TOSHIBA AMERICA INFORMATION SYSTEMS, INC.

Issue Alert Letter #26

A small number of Portégé 650CT users have reported what would appear to be a display-related problem. When the unit is powered on, a long beep (approximately 2 seconds) is sounded by the system. The unit will appear to be booting properly, but the display will remain dark. Closer inspection of the screen reveals that characters or Windows screens are actually being displayed, but they remain dark.

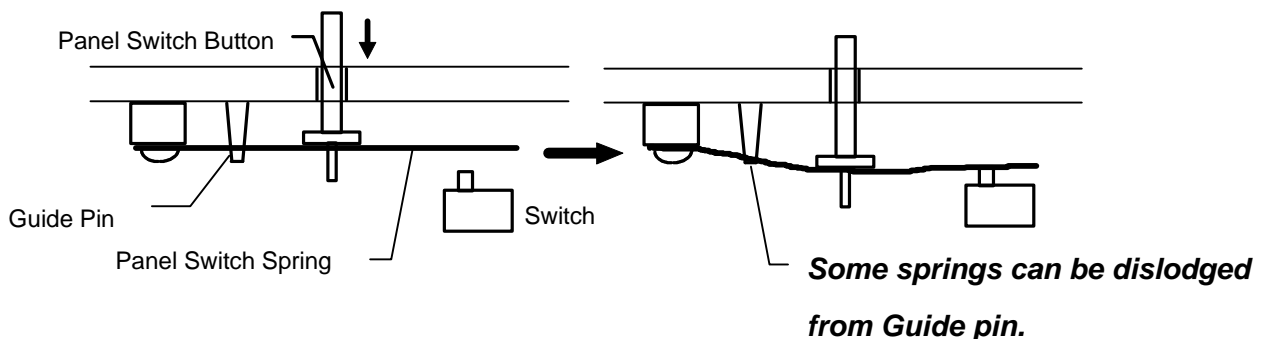
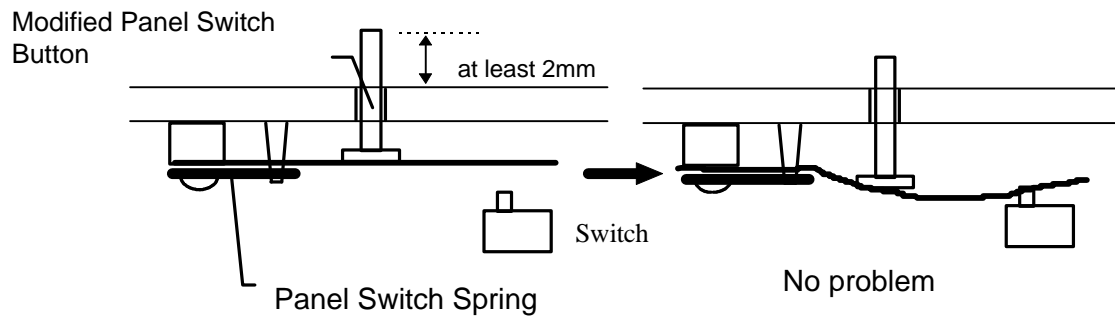
Two changes have been made to the panel switch assembly to prevent the button from binding.   A Panel Switch Spring Plate was added to the assembly to prevent the switch spring from becoming dislodged from a guide pin. The Panel Switch Button was also modified. A pin at the bottom of the button was removed to eliminate binding with the switch spring. Refer to the drawings below.

Some springs can be dislodged from Guide pin.

Modified Panel Switch Button
at least 2mm
Switch
No problem
Panel Switch Spring

The part number for the new Panel Switch Spring Plate is P000227690. The part number for the modified Panel Switch Button is P000227080; however, the current button can be modified by simply removing the pin at the bottom of the button.   The new parts will not be available for a few weeks.
